Cascades Leisure Centre

GCLC-ASP-B1-XX-RP-A-08101-P02

Addendum to the Design and Access Statement
January 2026

FIRST FLOOR PLAN

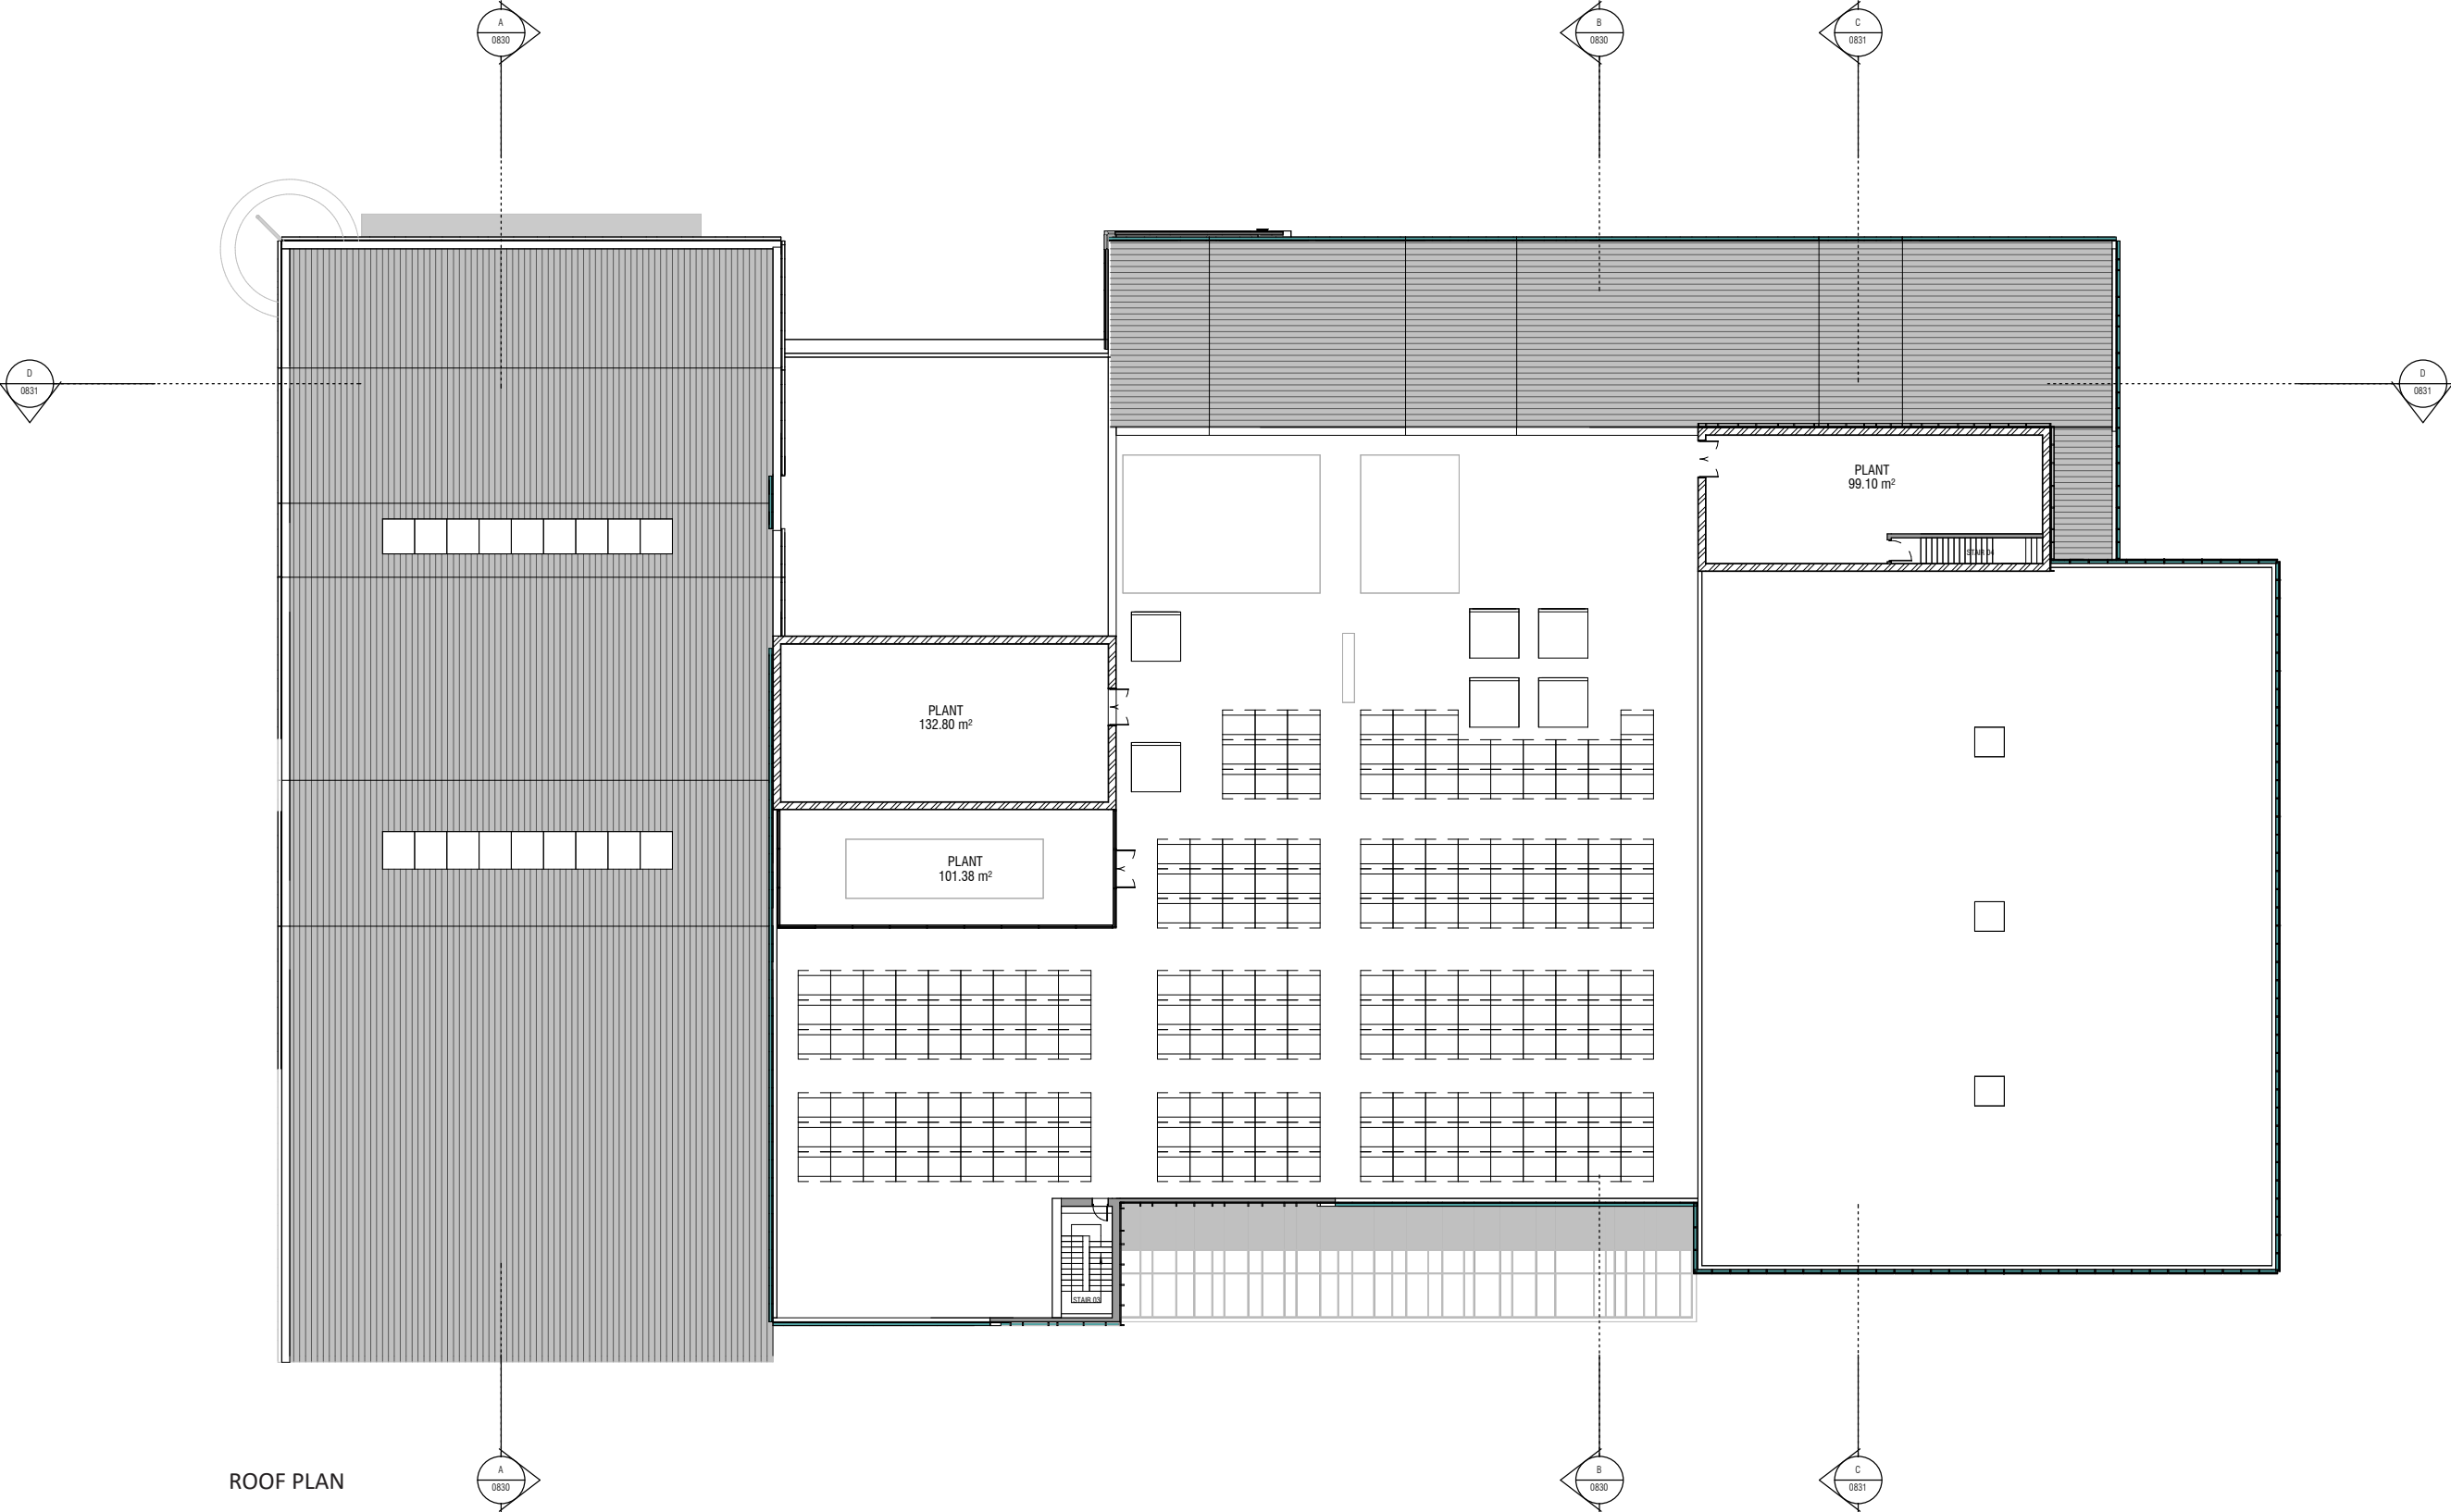
- Slight reduction in casual seating overlooking the swimming pool area, from 178.08 sqm to 167.1 sqm, (- 10.98 sqm).
- Removal of both squash courts (which are listed within the description of development). (-125.3 sqm)

- Reconfiguration of circulation, changing facilities and storage facilities.
- Relocation of spin studio to the existing area of the squash courts in the approved screen so there is an increase in space from 73.69sqm to 101.18 sqm.

- Reduction in space provided for studios and external terrace. Studio 1 and 2 previously provided 214.47 sqm and 153.74 sqm respectively with an external terrace of 166.02 sqm. Revised scheme to provide Studio 1 at 139.42 sqm and Studio 2 at 124.79 sqm with an external terrace of 27.23sqm. Reduction of terrace of 138.79 sqm from approved scheme. This retains the spatial requirements and activities from the approved scheme

- Reconfiguration of fitness suite to increase provision from 485.88 sqm to 540.62 sqm. (+54.74 sqm)
- Removal of plant space of 189.37 sqm (plant and server room)

- Void over soft play zone repositioned and reduced to suit new location of soft play

ROOF PLAN

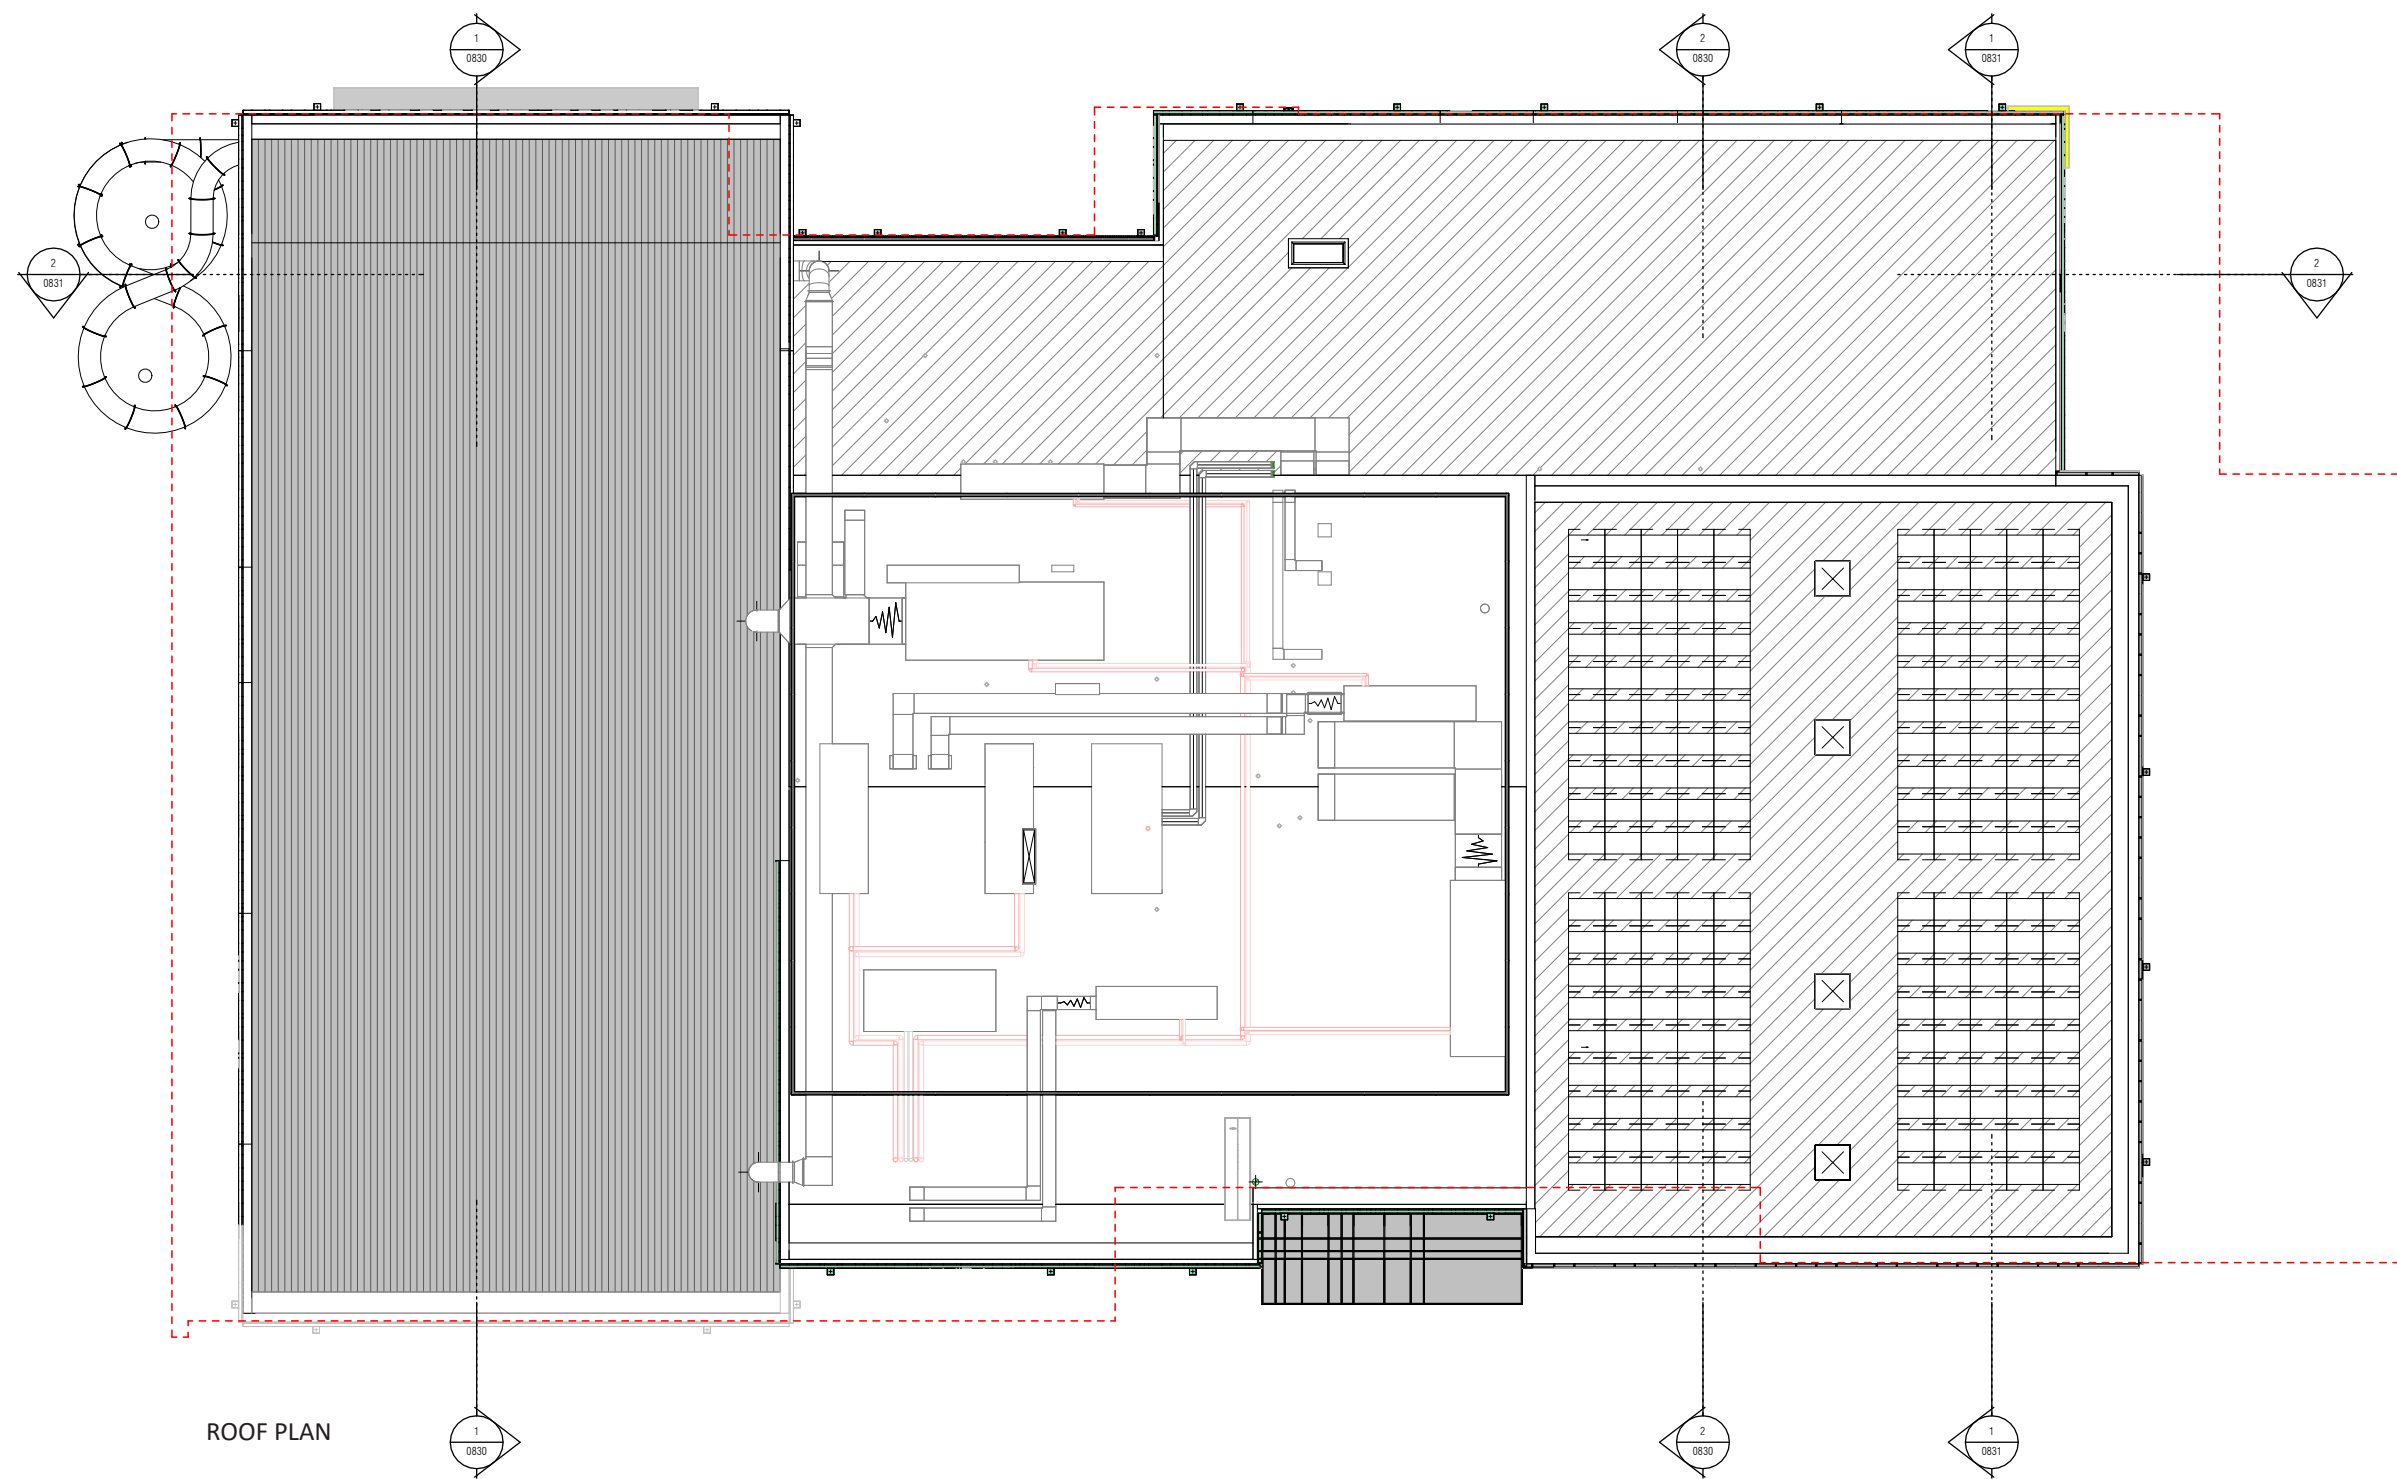
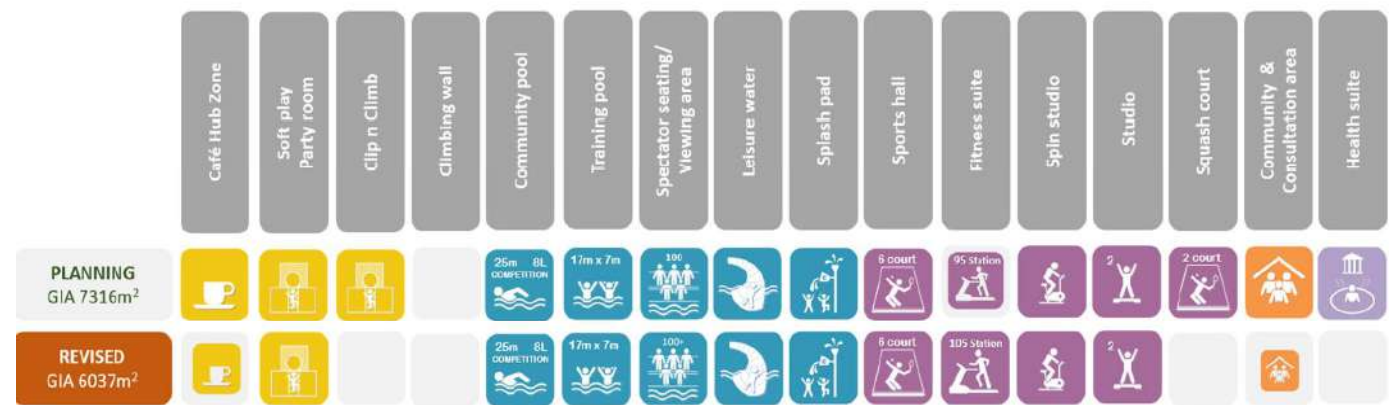
- Removal of plant rooms. (333.28 sqm)
- Removal of sedum roof. Condition 19 part (iii) requests detailed information for the design and specification of a sedum roof and details of irrigation systems. (231.52 sqm).
- Simplification to the roof falls and structure in conjunction with the general lowering of roof heights.
- New plant screen to house the external M&E AHU's and other servicing plant. The ducts will be routed across the roofs and dropped into the building.
- Repositioning of PV panels to suit roof proposals

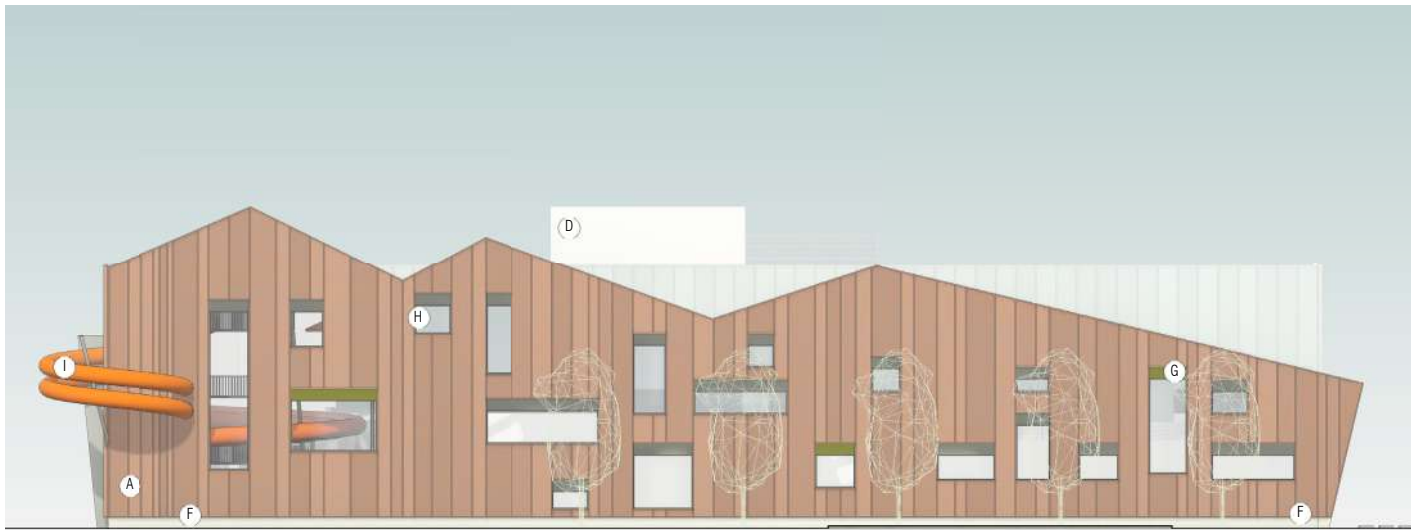
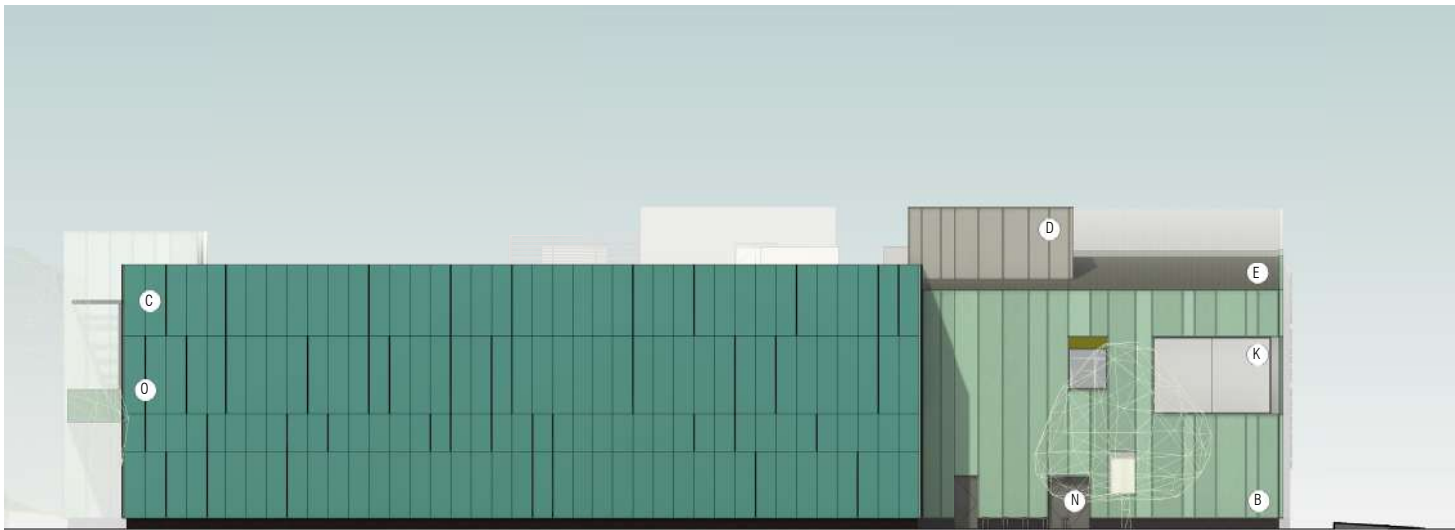
- Lowering of façade and alternative appearance to sports hall cladding
- New soft play window feature and treatment
- Reconfiguration of openings and treatment to suit new internal layout

- Simplification of openings
- Flume reconfigured
- Simplification and lowering of façade

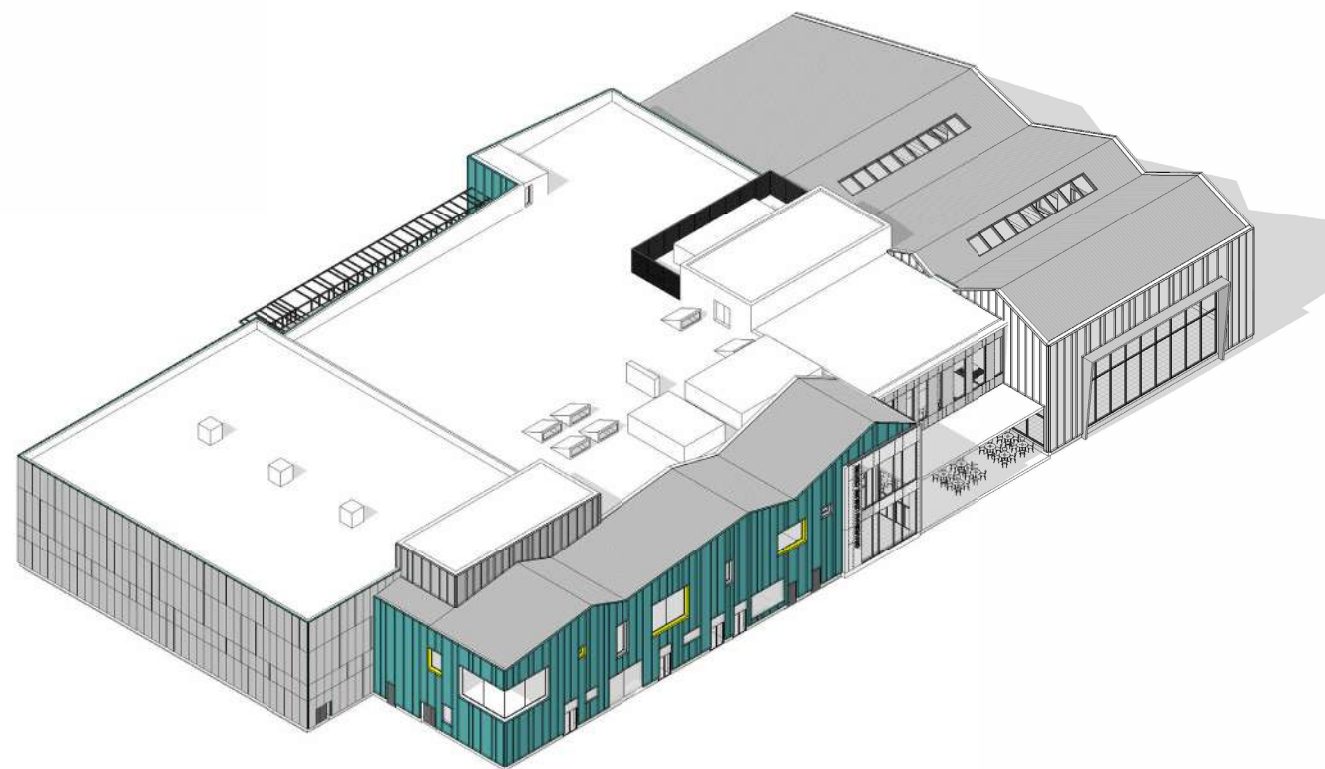
1. Aluminium cladding panels fixed to the carrier panel, with colour-matched profiles and folds designed to visually replicate the patinated green copper effect cladding. There will be 3 different spacings for the vertical features to appear as randomisation.
2. Aluminium cladding panels fixed to the carrier panel, with colour-matched profiles and folds designed to visually replicate the brown copper/bronze effect cladding system. There will be 3 different spacings for the vertical features to appear as randomisation.
3. Light grey aluminium metal cladding panels fixed to the carrier panel.
4. Grey aluminium cladding panels with exposed feature fixings, installed on the carrier panel.
